Mandatory Service Bulletin

MSB No. ES01 Rev 2

Dual Magneto Impulse Coupling

Figure 1

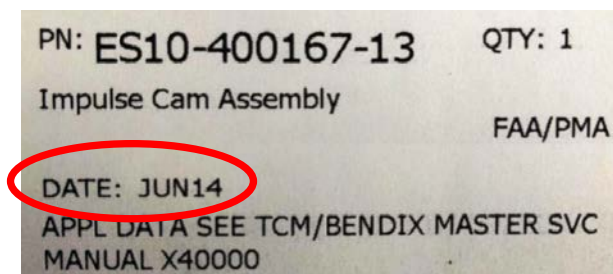
Part Numbers					
ES10-400166-7	ES10-400167-7	ES10-400167-8	ES10-400167-9	ES10-400167-12	ES10-400167-13
Effective Date Codes (see Figure 1)					
JAN14	FEB14	MAR14	APR14	MAY14	JUN14
JUL14	AUG14	SEP14	OCT14	NOV14	DEC14
